SUBJECT: Response to NRC Query of Decommissioning Test Area C-74L, Eglin Air Force Base, Florida

SUBJECT: Response to NRC Query of Decommissioning Test Area C74L Eglin AFB FL

SUBJECT: Decommissioning Plan for Test Area C-74L, Eglin Air Force Base, Florida

Comments/Questions Related to Eglin Air Force Base Decommissioning Plan

FIGURE 1
IRP SITE NO. RW-41 TEST AREA C-74L
GUNNERY BALLISTIC FACILITY
PROPOSED SITE FINAL STATUS SURVEY
SOIL SAMPLING PROGRAM

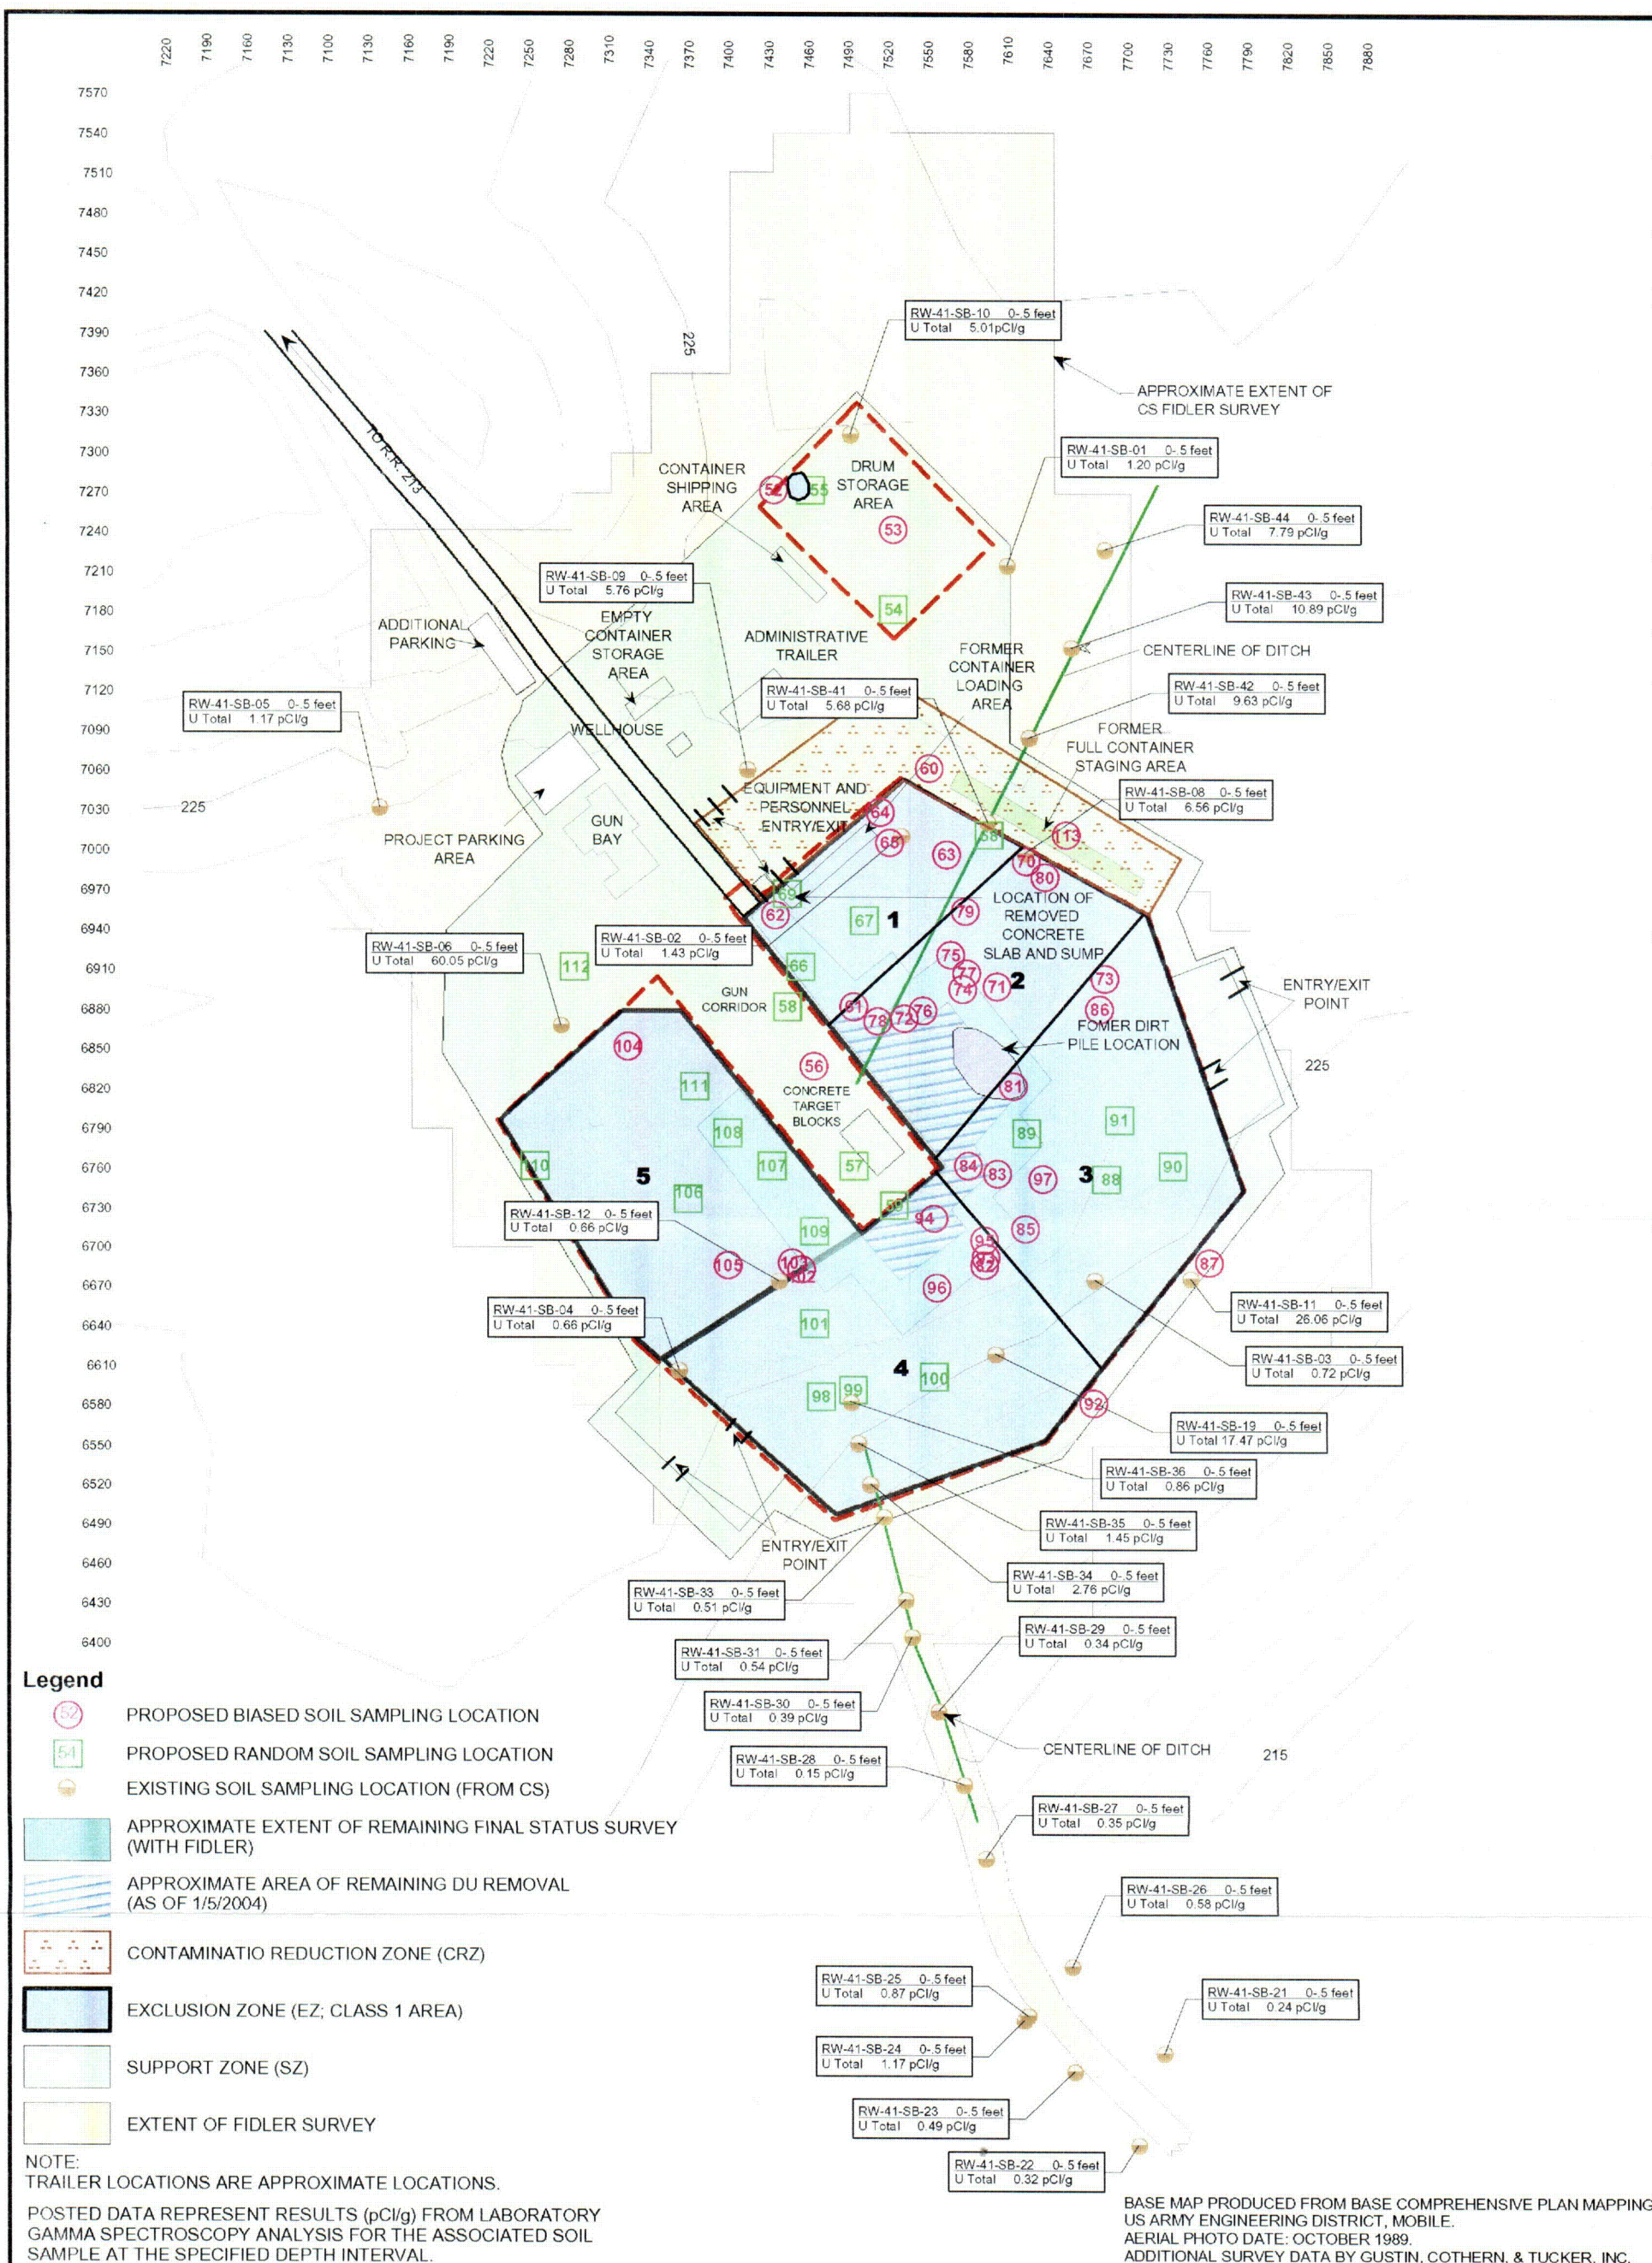
3. **The number of soil samples to be collected as part of the final status survey is inconsistent across the site. Please clarify the number of soil samples that will be collected site-wide and justify the proposed number if less than the number recommended in MARSSIM for each survey unit classification.**

The FSS soil samples will consist of three types: existing soil samples collected during the Characterization Study (CS) in 1999; new biased soil samples; and new random soil samples. The attached Figure 1 shows the locations of these samples. A total of 31 CS soil samples, 30 biased soil samples, and 30 random (unbiased) soil samples will be collected at locations within the gun corridor, former drum storage area, and Areas 1 through 5 of the radiation controlled area. This represents a total of 91 soil samples throughout the site.
